## PLANNING & ZONING COMMISSION AGENDA

**Subject: Development Clearing Permit – Brighthouse Learning 21464 Clear Creek Drive**

**Subject: Variance 101 Abita Oaks Blvd**

# 21464 Clear Creek Driveway 12' Width Revision

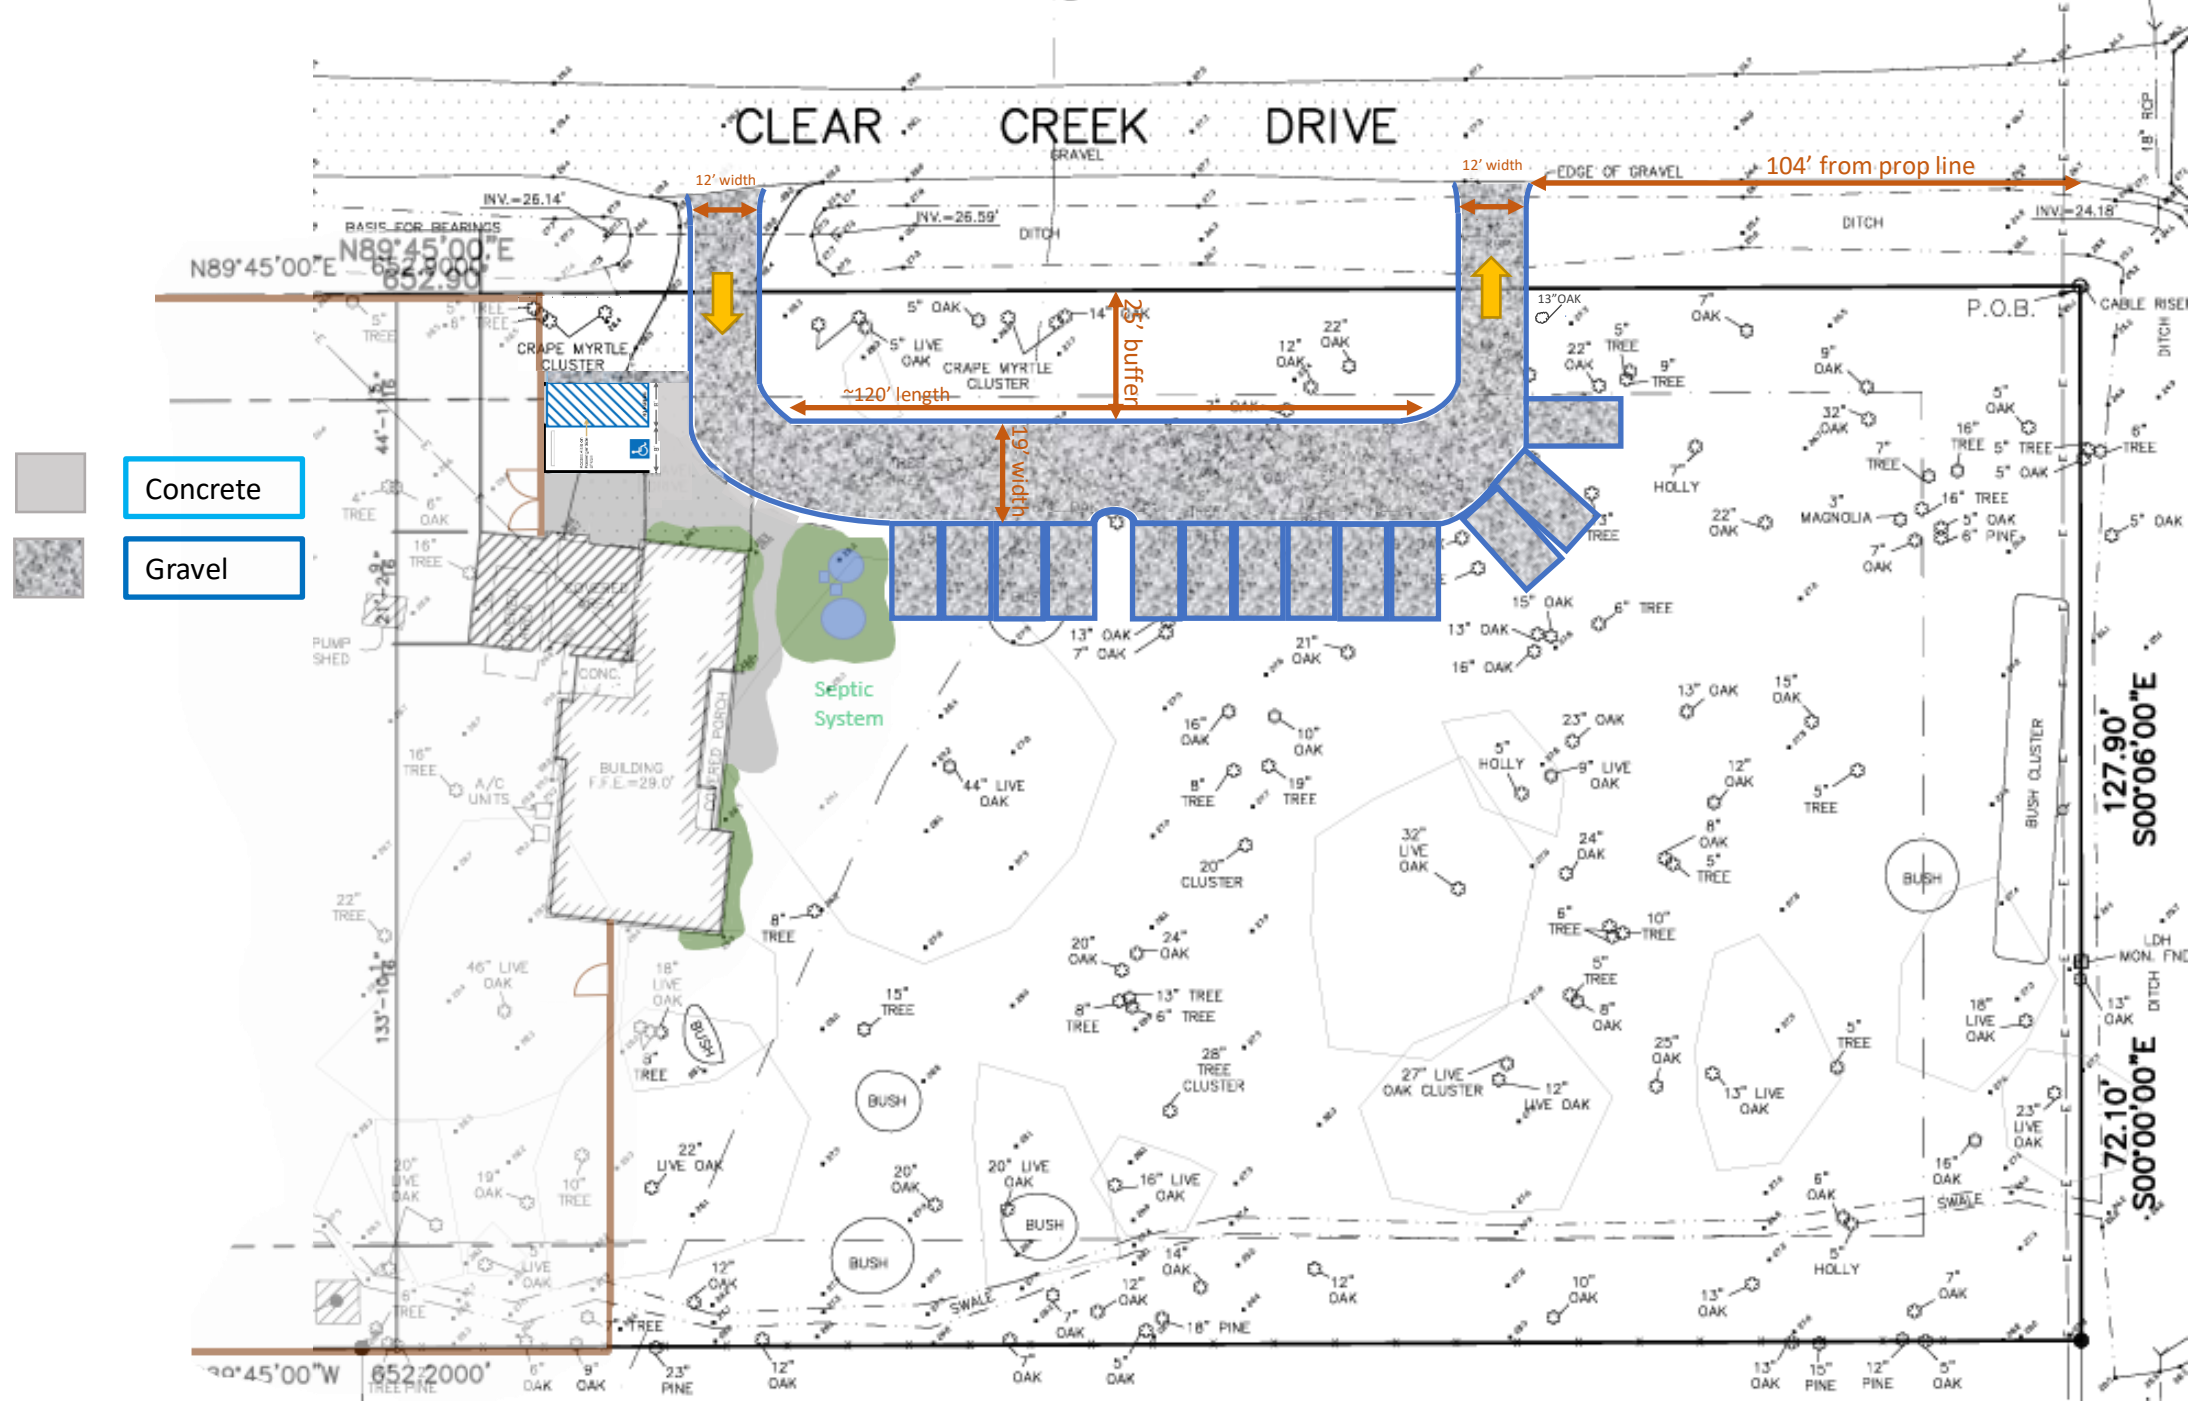
The current driveway on Clear Creek Drive will be expanded with a second access point to serve as a one-way circular drive. (Note: The Louisiana Department of Transportation and Development confirmed that with access available on Clear Creek Drive, an additional access on Hwy 59 would not be permitted.) The driveway width would be 12 feet, which meets the standard for one-way drives from Town Code Sec. 3-408(a).

The proposed school would have three (3) classrooms – one each for elementary, junior high, and senior high students. The applicants' site plan shows 14 parking spaces, including one ADA-accessible parking space. The number of parking spaces shown on the site plan meets the parking requirements of Section 9-211(d).

# 21464 Clear Creek Tree Removal

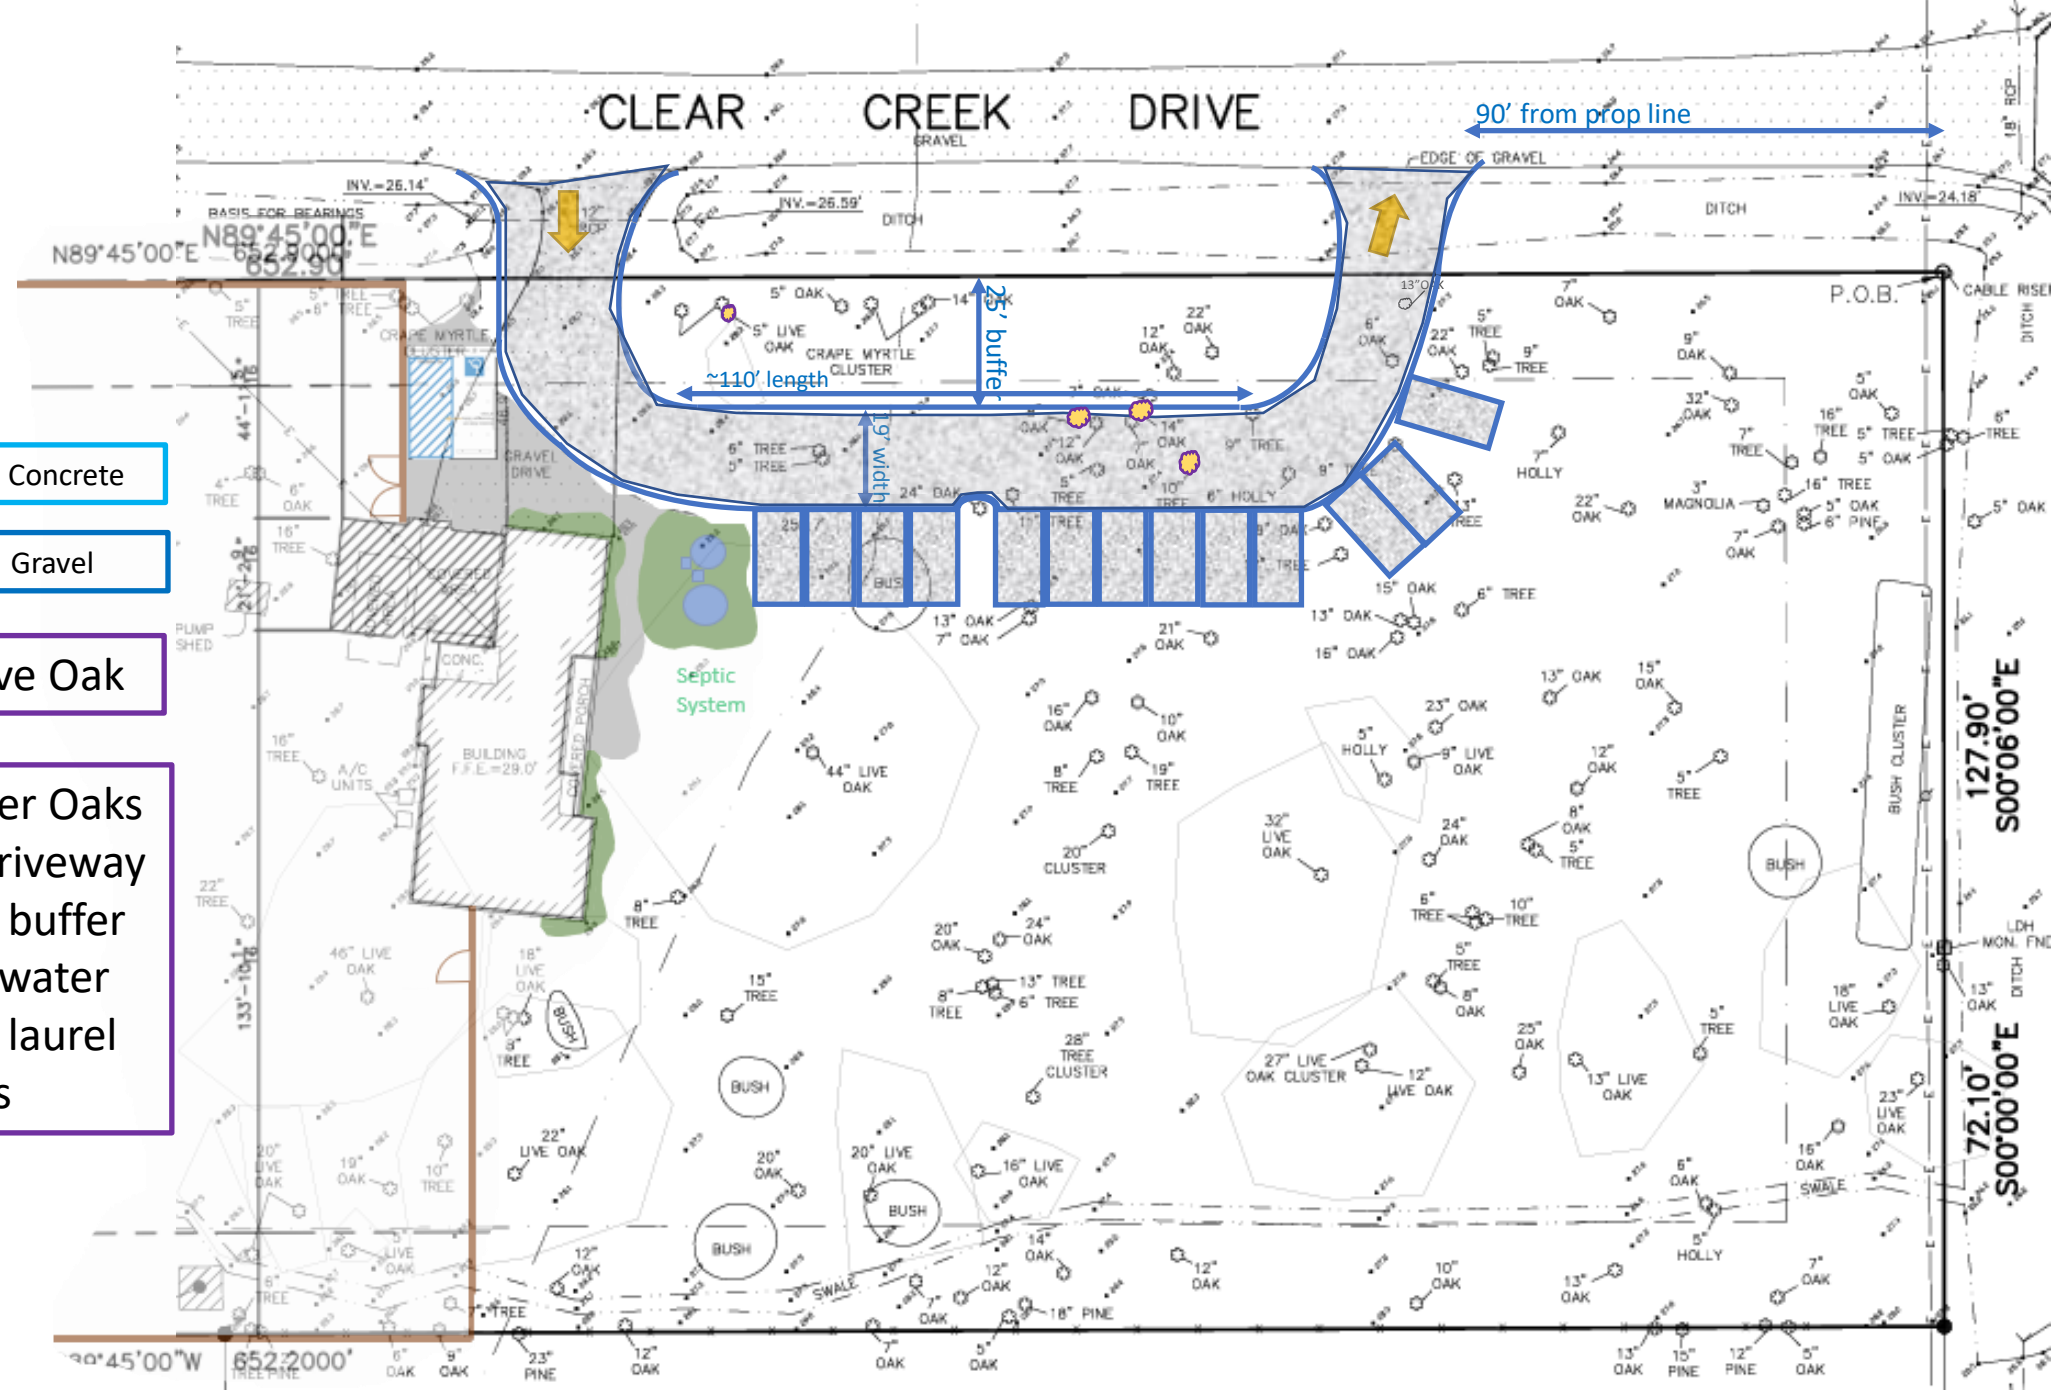
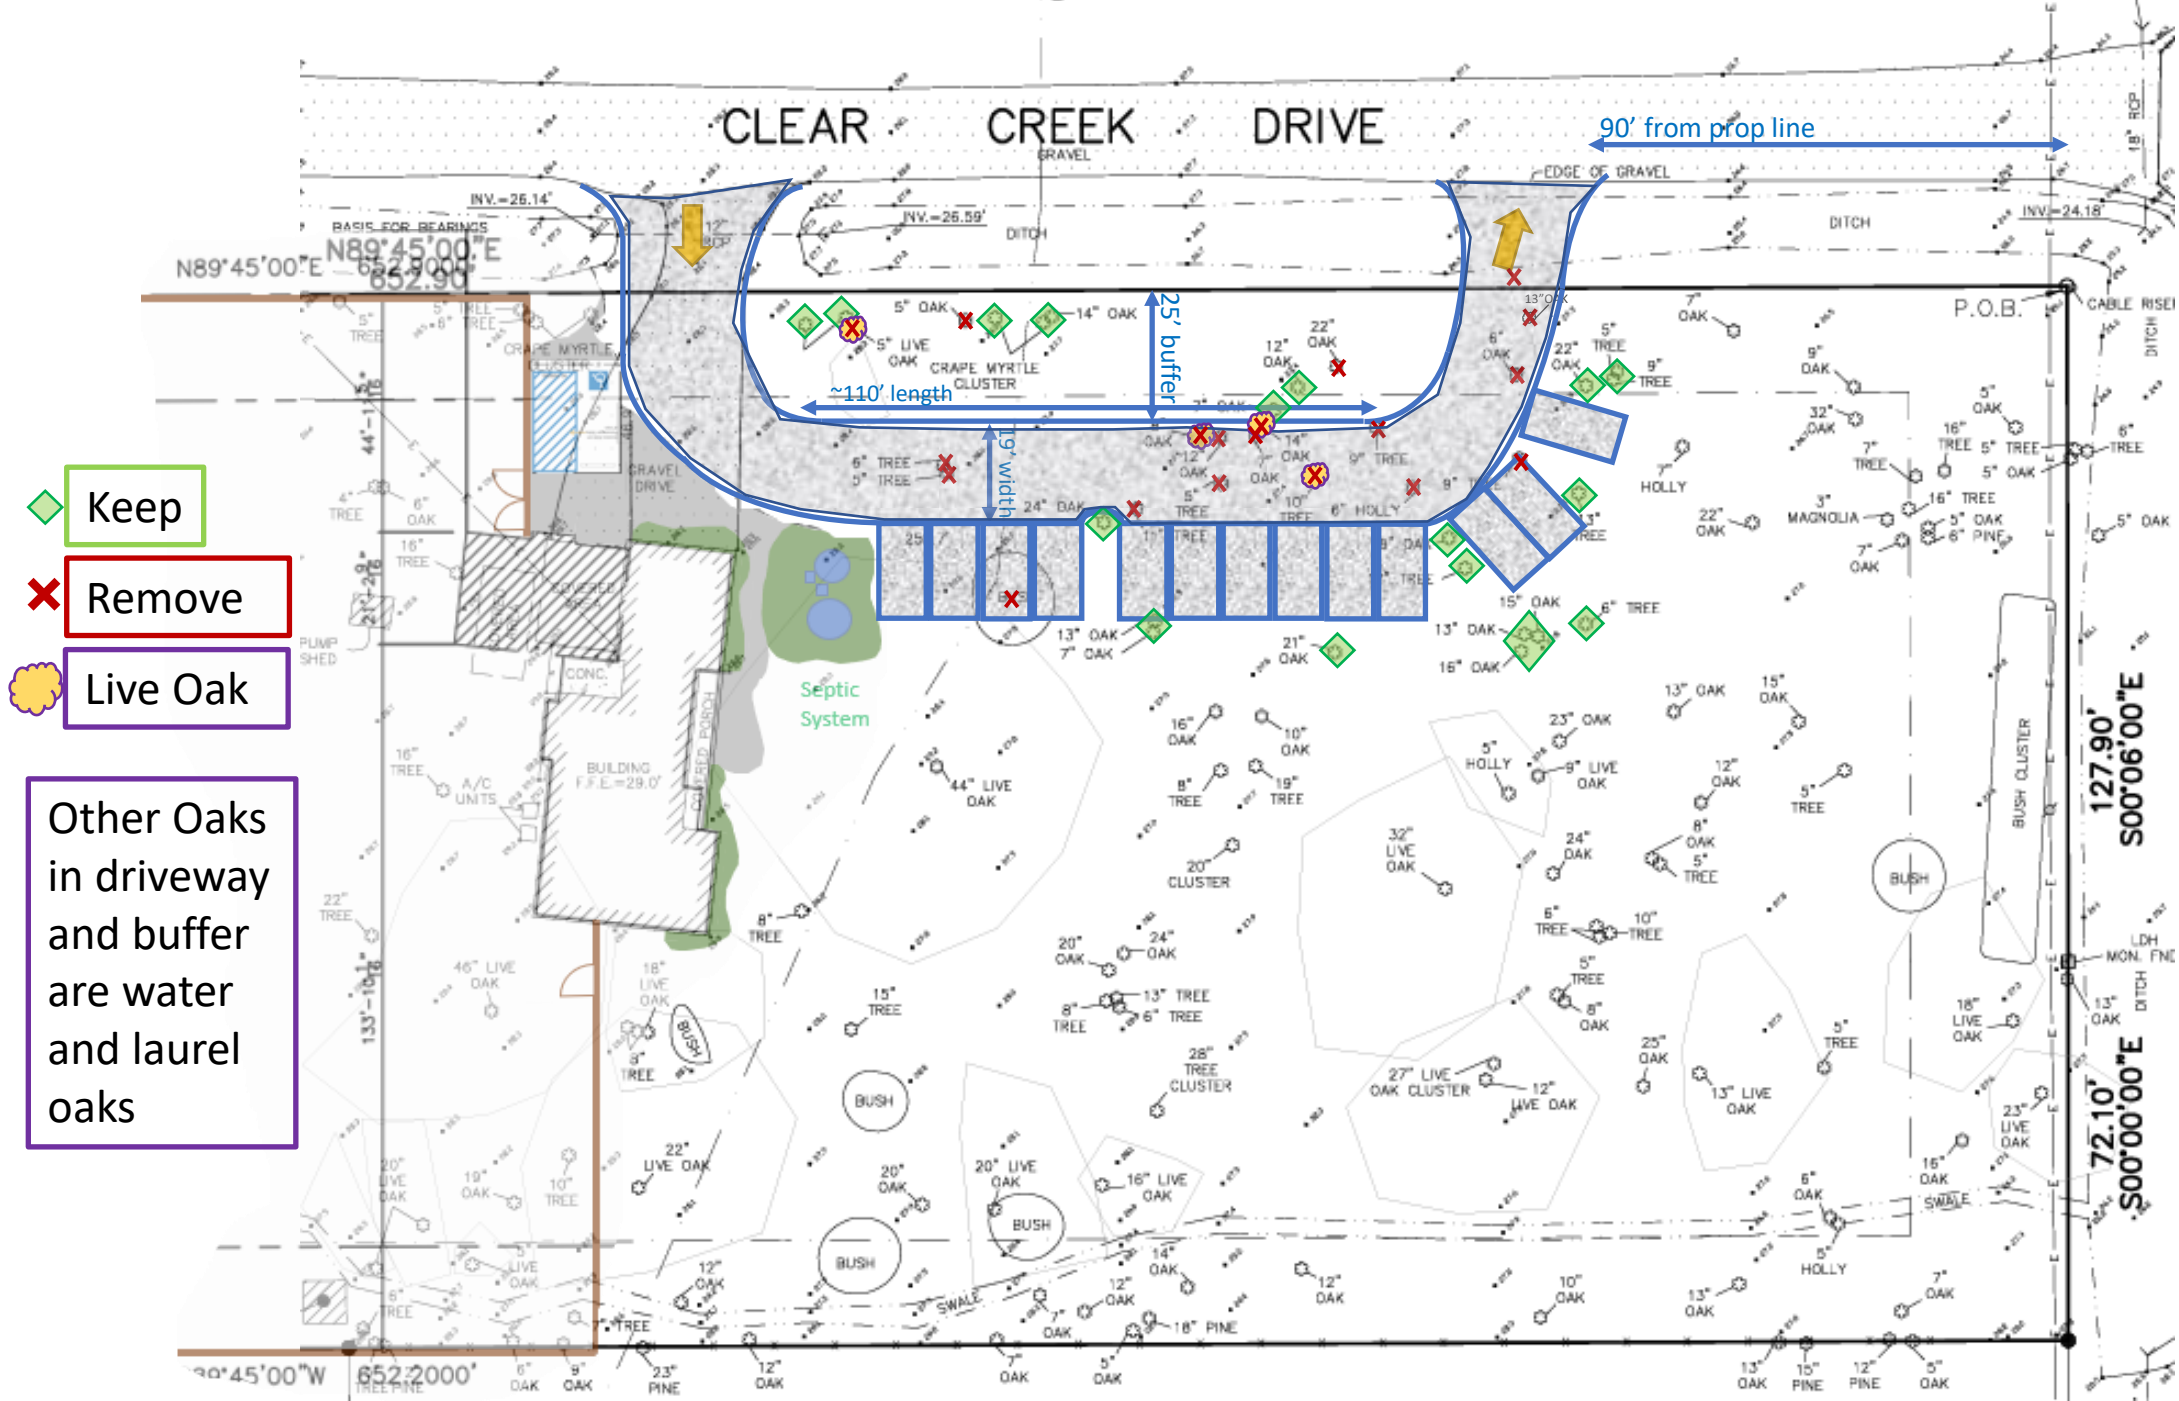
To develop the circular drive and parking area 19 trees need to be cleared. Town Code Sec. 9-703(b) requires issuance of a Development Clearing Permit for any nonresidential development that requires removal of five (5) or more trees.

**Staff response:** The applicants have submitted a tree removal plan that meets the requirements of Sec. 9-708 (d). Dr. Malcolm Guidry has reviewed the tree removal plan and has approved the plan subject to Planning and Zoning Commission approval to issue a development permit and notice to proceed.

# Erosion and Sediment Control Plan

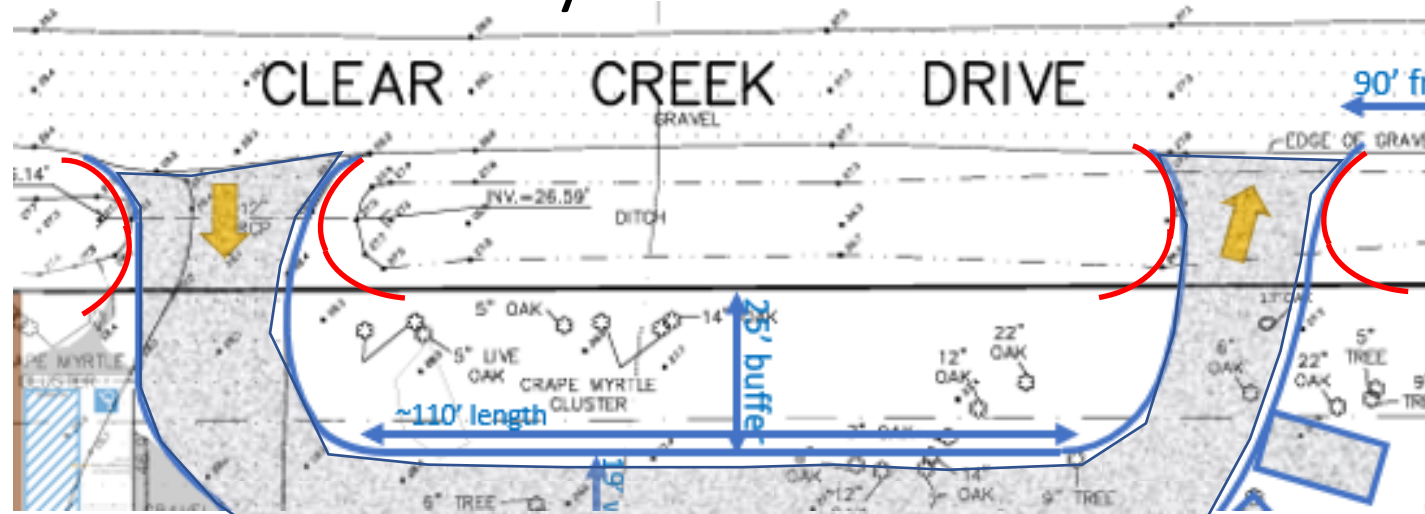
The erosion and sediment control plan included as part of the tree removal plan and the drainage plan have been reviewed by the Town's drainage consultant. The drainage consultant has approved the drainage plan and specified areas where silt fence barriers are required.
